Public Input No. 1740-NFPA 70-2023 [Definition: Branch Circuit, Motor. (Motor Branch Circuit)]

Public Input No. 177-NFPA 70-2023 [Definition: Industrial Control Panel.]

TCC Name: <u>_MOTORS</u>	Current x 0.1	Reference Voltage: 480
Online: <u>_MOTORS</u>		
Date: Mav 12. 2023 10:54 AM		SKM Svstems Analvsis. Inc.

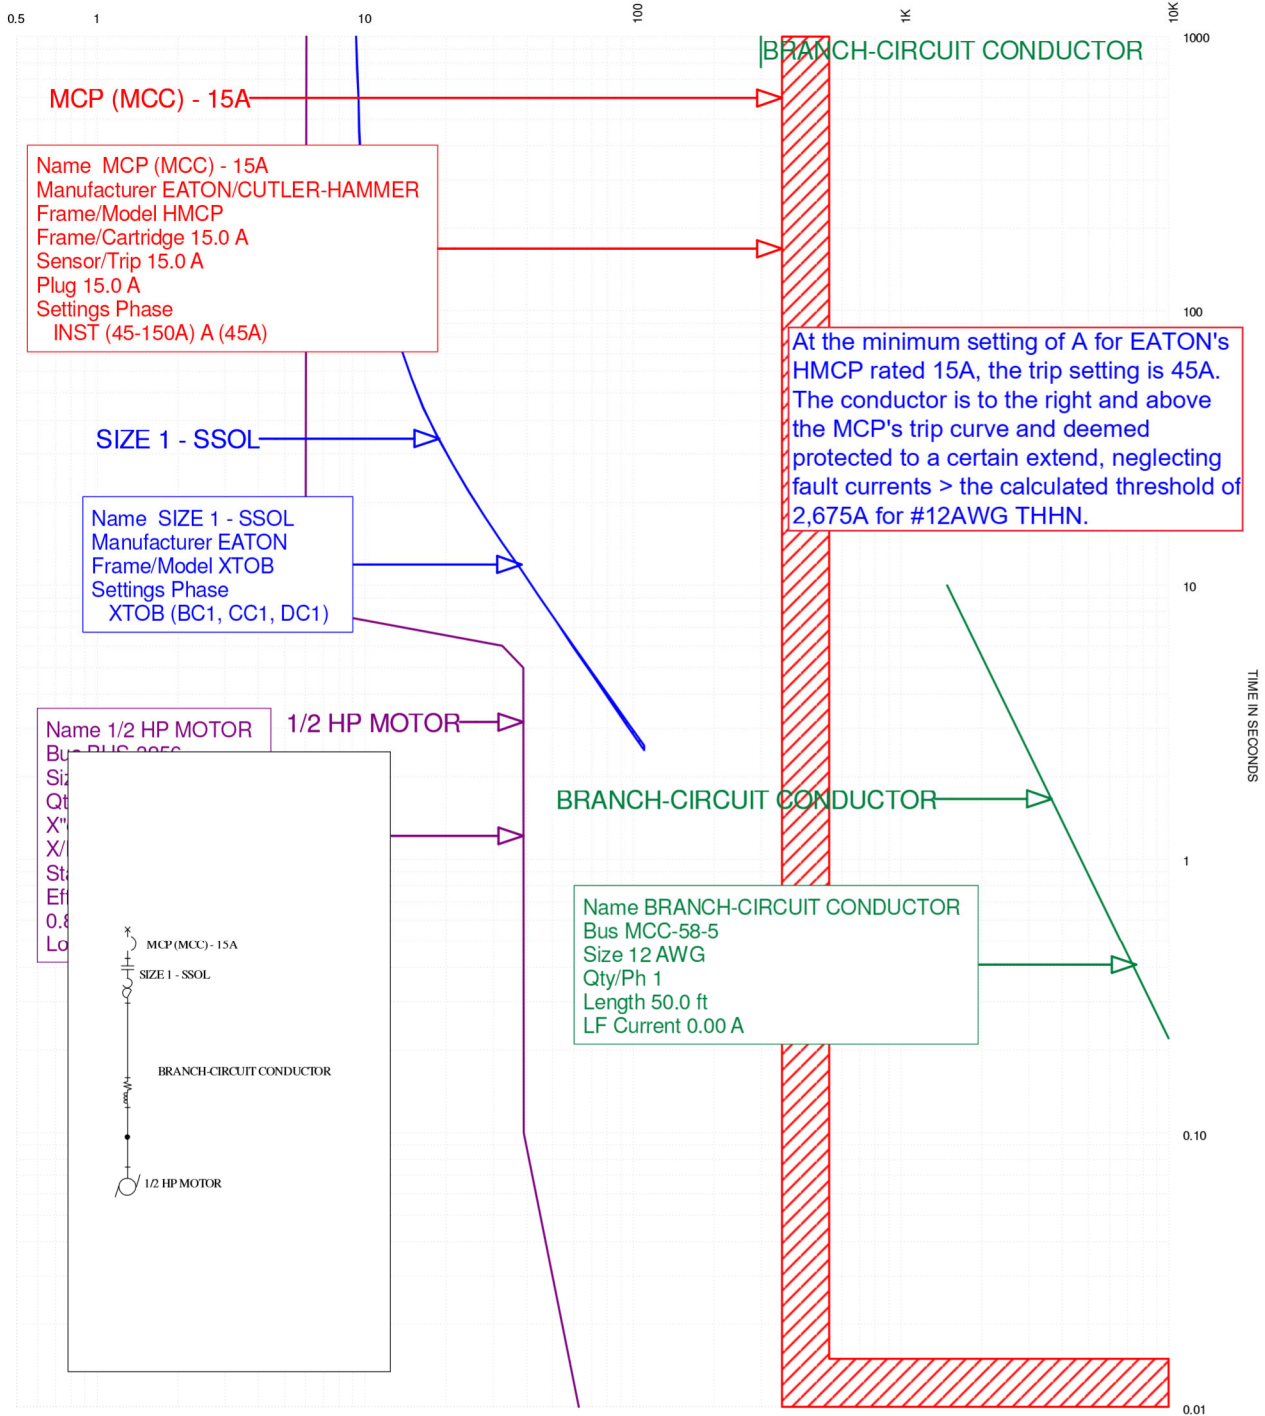
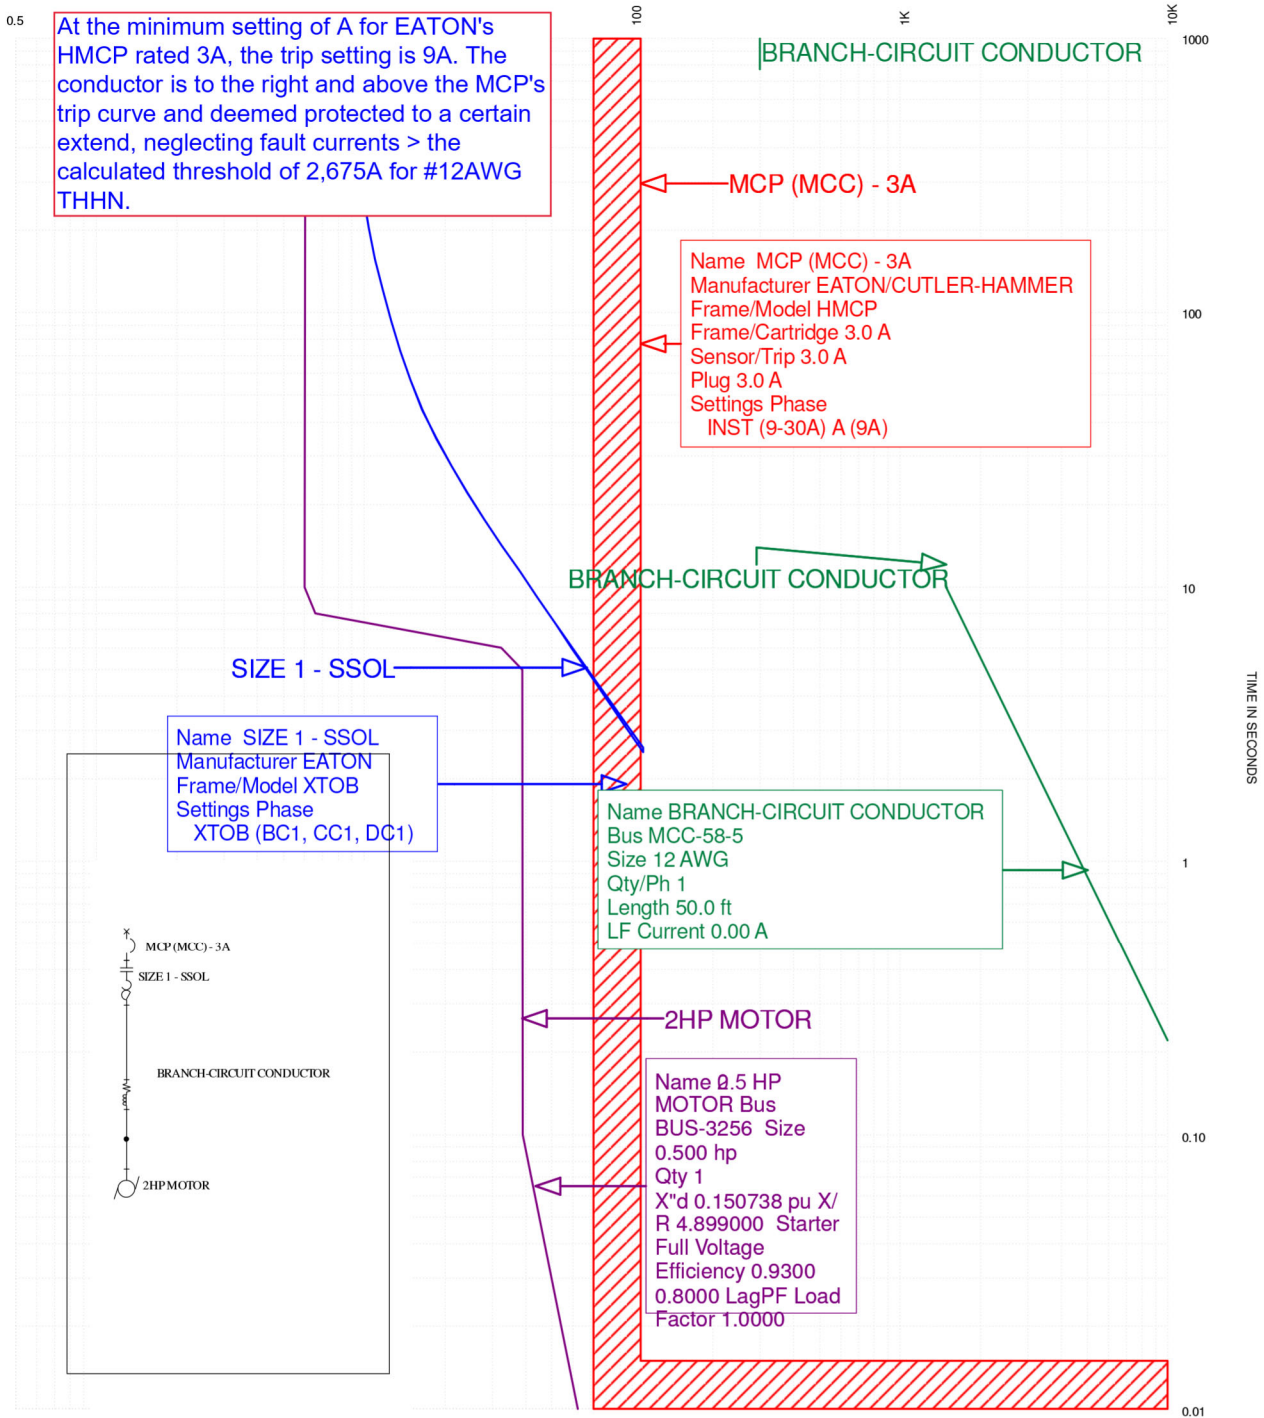
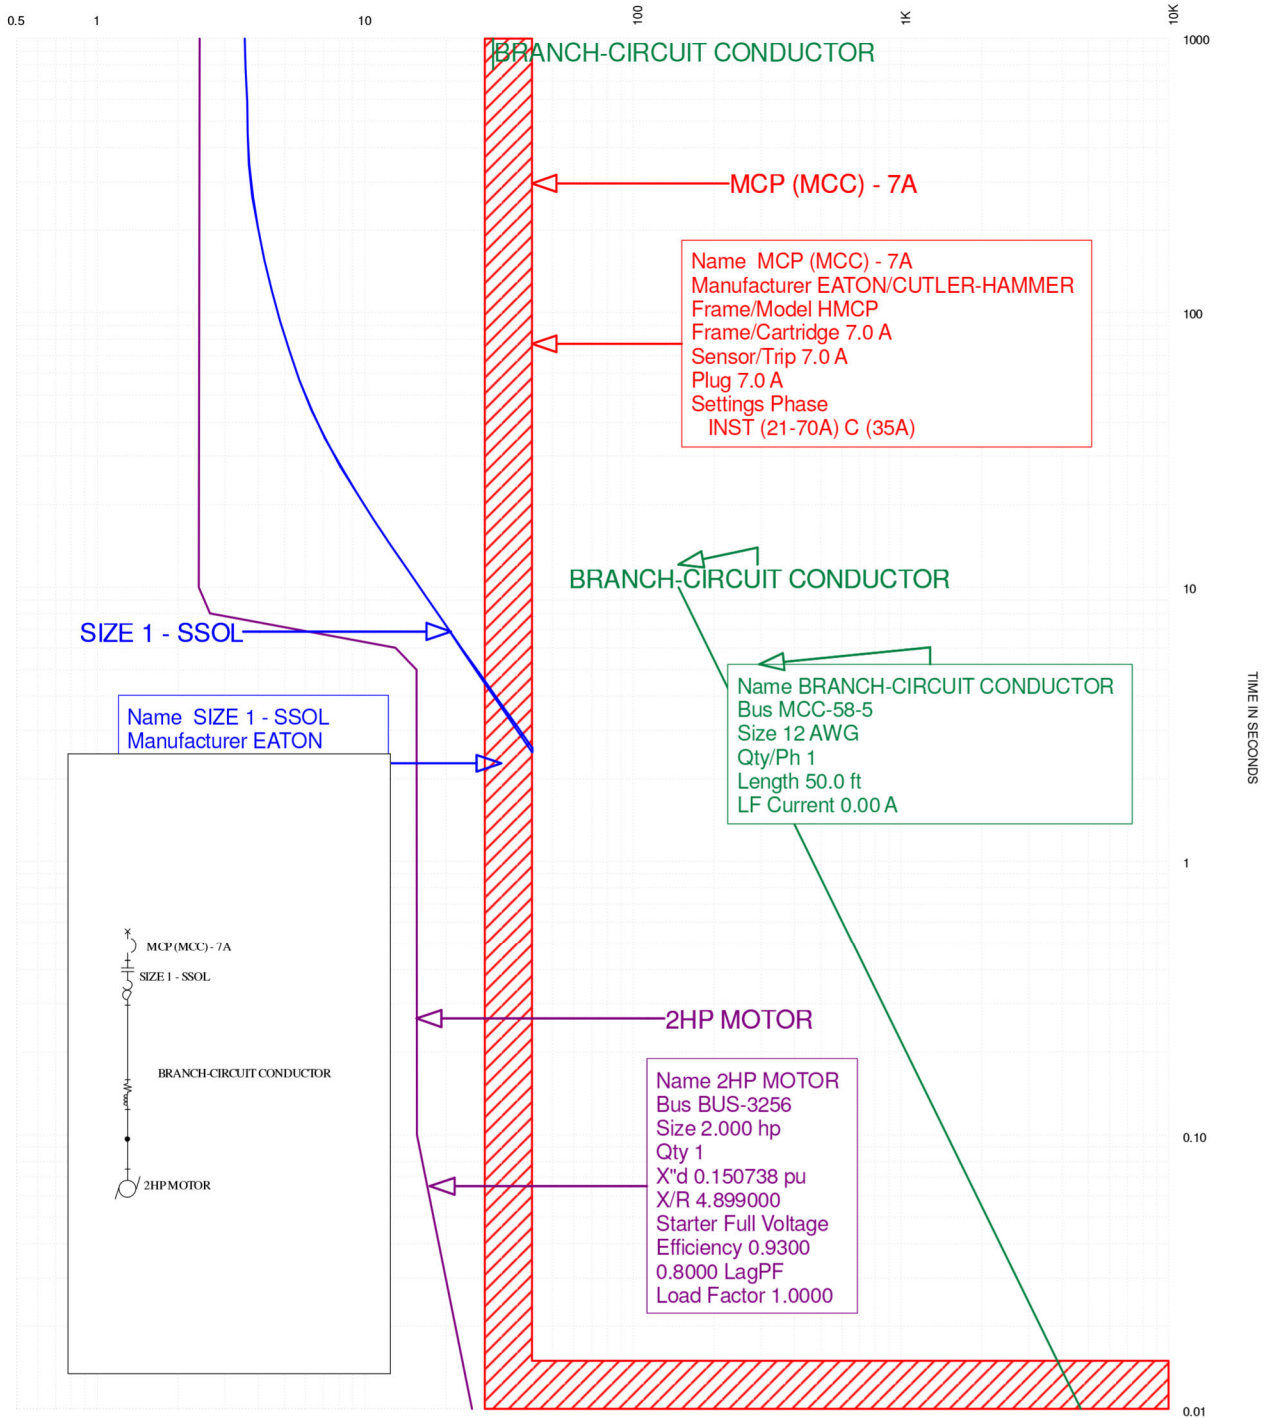
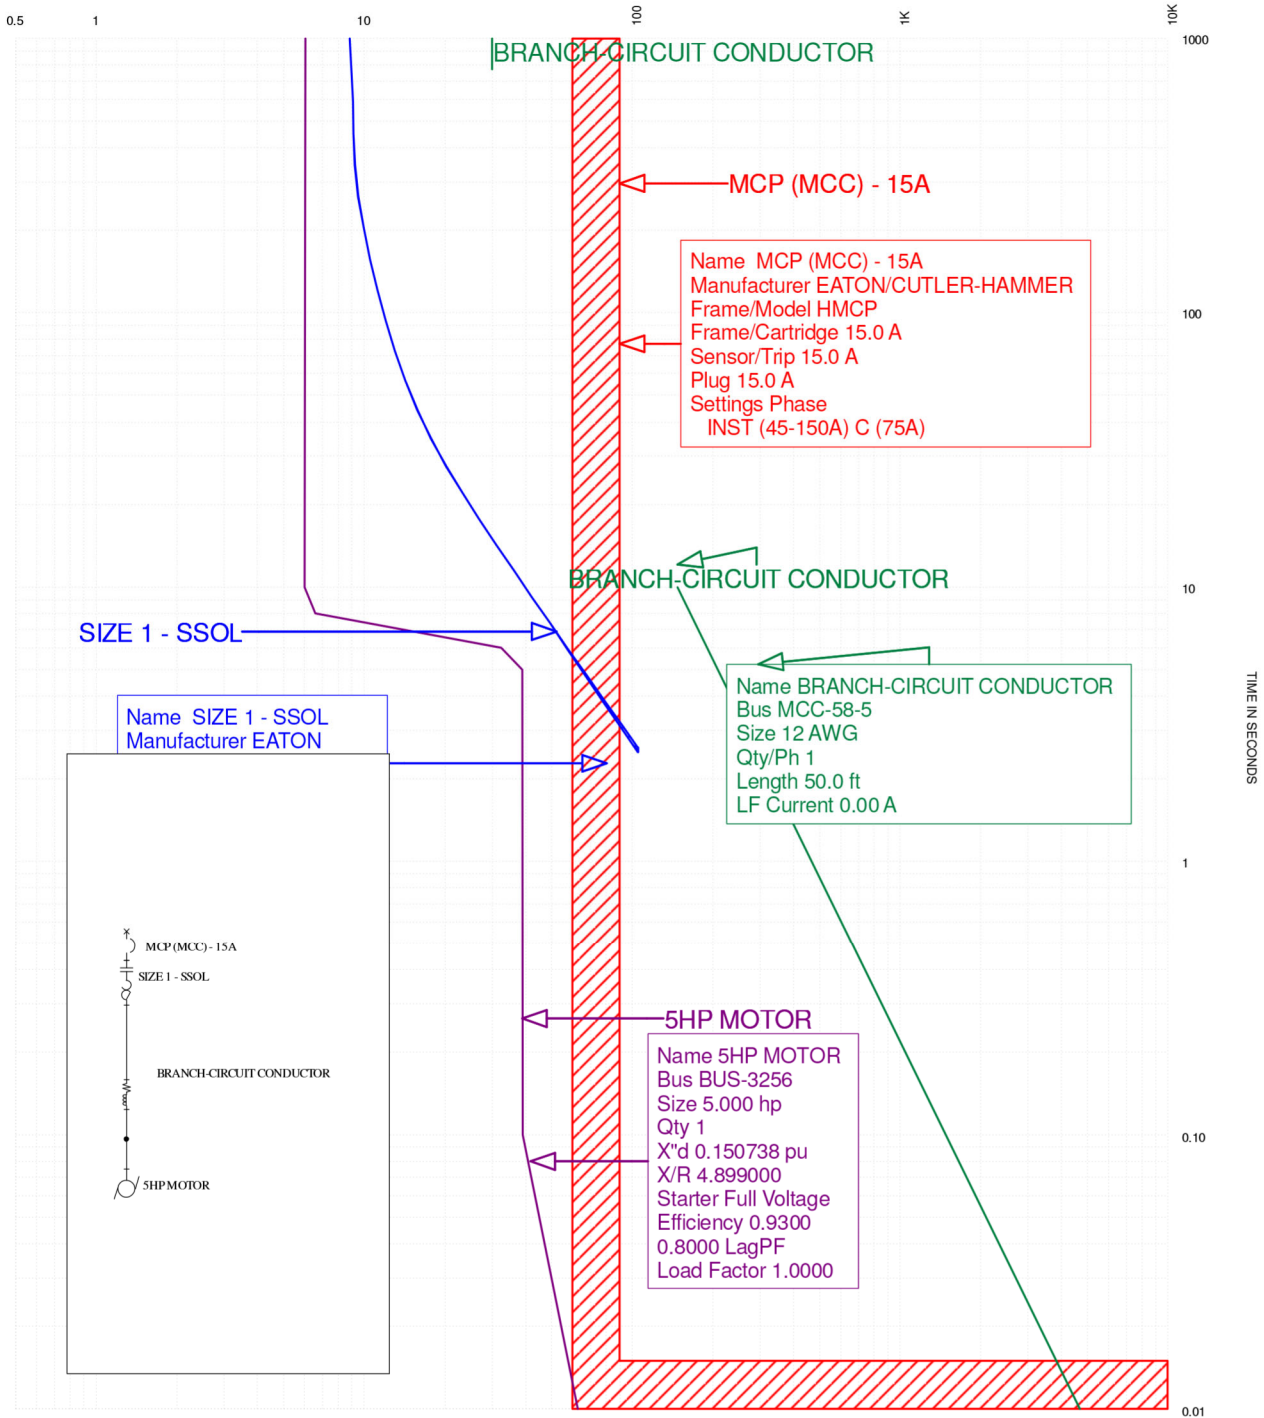
In 430.52(C)(3)(b)(2)a. of the 2023 National Electrical Code, a value of 1300 percent is specified for all motor types in Table 430.52(C)(1) other than Design B energy efficient and Design B premium efficiency. Since the introduction of Design BE and CE introduces a new exception to the 1300 percent specification, it is proposed to specify a value for each of the motor types shown in Table 430.52(C)(1) instead of specifying a single value with a list of exceptions. This does not change the adjustable instantaneous-trip setting specified in 430.52(C)(3)(b)(2) of the 2023 National Electrical Code for any motor type with the exception of the Design BE and CE, energy-efficient Design C, and premium efficiency Design C motor types already mentioned.

Resolution: Instantaneous trip circuit breakers do have a continuous current rating as marked on the handle. Setting the mag level to the lowest setting does not correspond to UL testing requirements for highest setting.
